GOVERNMENT OF THE DISTRICT OF COLUMBIA
DEPARTMENT OF TRANSPORTATION

MEMORANDUM

SUBJECT: **BZA Case No. 19257** – Cleveland Park Library, 3310 Connecticut Avenue, NW

APPLICATION

Figure 1: Study Area (Source: Grove/Slade Associates)

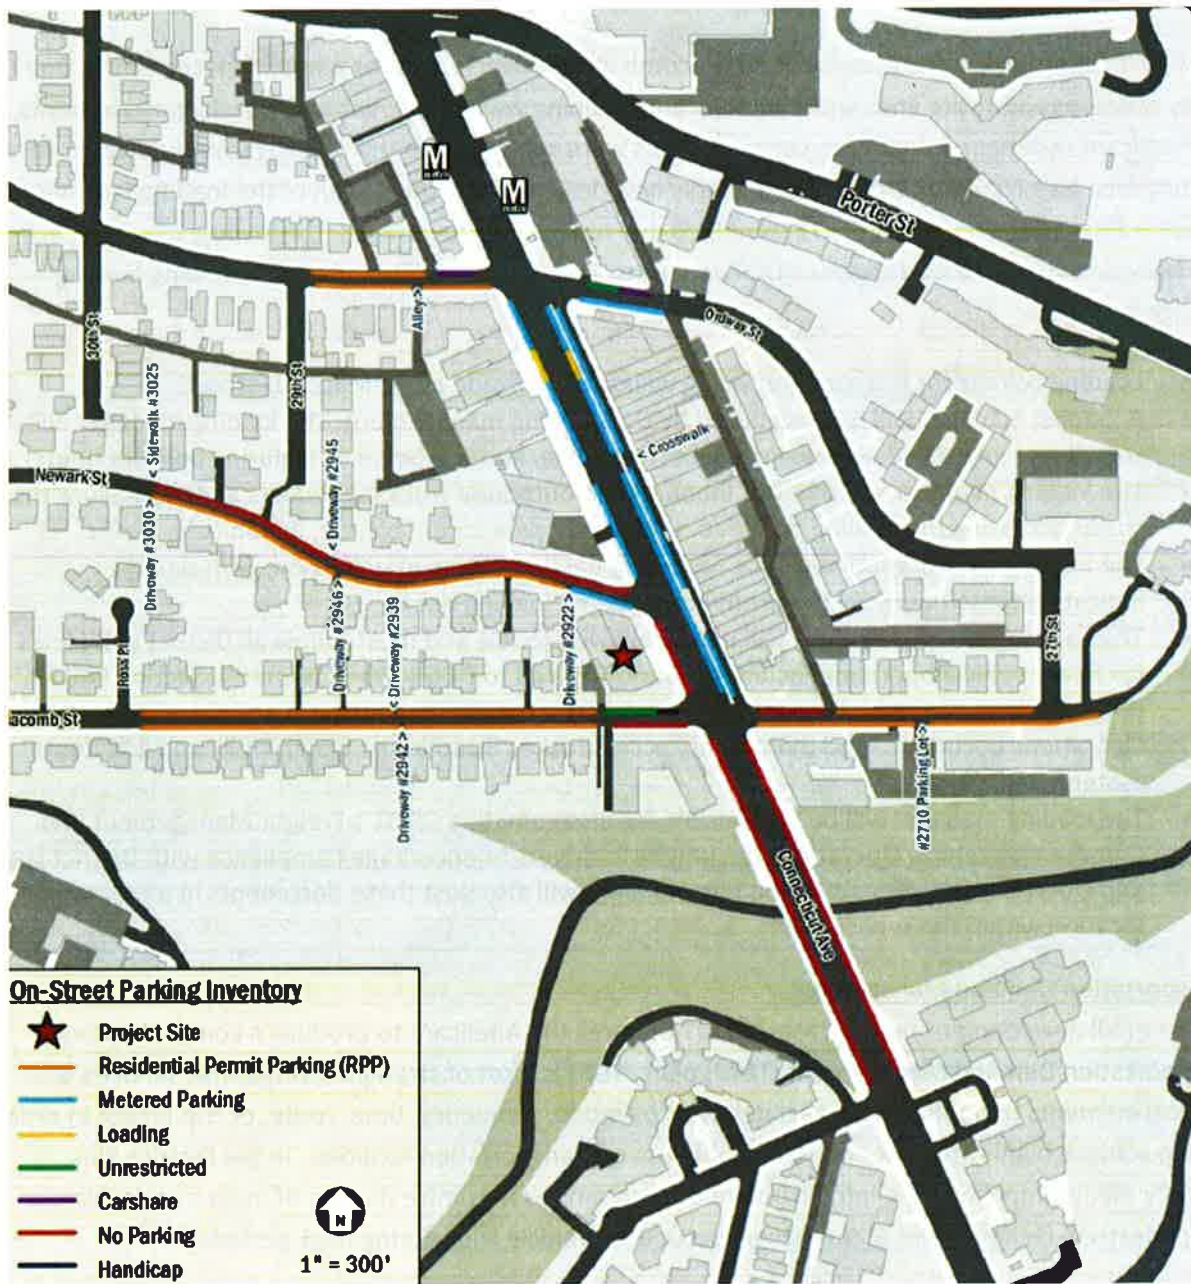
Zoning requires the provision of 16 parking spaces, and the Applicant requests full parking relief. A parking occupancy study was conducted by the Applicant, which was coordinated with DDOT. Parking occupancy data was collected on Tuesday, April 5, 2016 from 11:00 am to 2:00 pm and 5:00 pm to 8:00 pm to overlap with peak parking demand. The study area consists of 157 Residential Parking Permit two-hour restricted spaces, 76 metered spaces, 7 loading spaces, 4 carshare spaces, 1 handicap space, and 5 unrestricted spaces.

The analysis shows unused nearby on-street parking that would meet the proposed project's parking demand, with 41 spaces available during mid-day peak weekday demand in the study area (1:00 pm to 2:00 pm) and 38 spaces available during evening peak weekday demand (7:00 pm to 8:00 pm) (see Figures 1 and 2).

MACOMB STREET NW
 Figure 3: Updated Loading Facility Design (Source: Perkins Eastman DC)

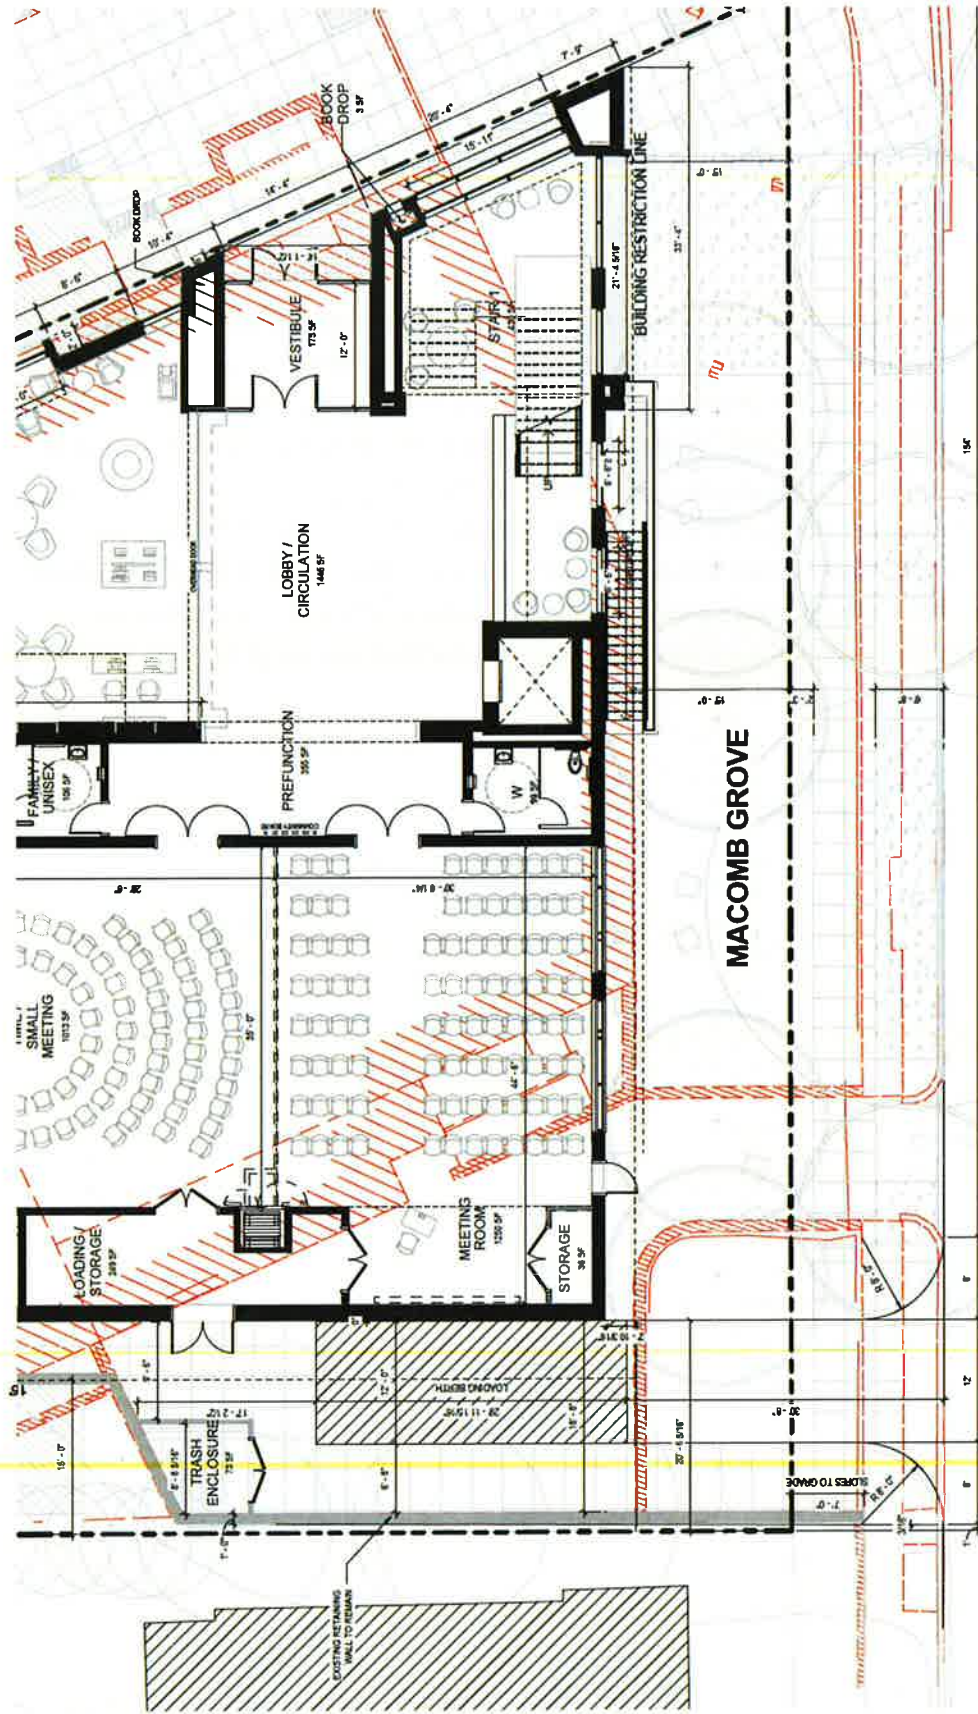
- On-Street vehicle parking supply is available to meet the project’s parking demand;
- Two bus routes and a Metro station are either immediately adjacent to or within one-quarter mile of the site;
- The design of the loading facility on Macomb Street does not meet DDOT standards due to backing movements. However, the loading management plan provided adequately addresses DDOT concerns;
- The Applicant will need to apply for public space permits for the relocated curb cut and all work in public space; and

The Applicant proposes a new curb cut on Macomb Street, which requires a public space permit. Due to safety concerns about site lines with the adjacent retaining wall, compounded by backing movements, the Applicant redesigned their curb cut since plans were submitted to the BZA to move it adjacent to the building face (see Figure 3). DDOT supports this new design. While the design of the loading facility on Macomb Street does not meet DDOT standards due to backing movements, the loading management plan provided adequately addresses DDOT concerns. The Applicant agreed to the following loading management plan:

- Loading activity for trash and recycling will occur curbside along Macomb Street;
- A loading manager will be designated by the building management. The loading manager will coordinate and schedule deliveries where possible, and will be on duty during delivery hours;

- The loading manager will monitor inbound and outbound truck maneuvers and will ensure that trucks accessing the loading docks do not impede pedestrian, bicycle, or vehicular traffic;

- The loading dock operation will be limited to daytime hours of operation, with signage indicating these hours posted prominently at the loading dock;
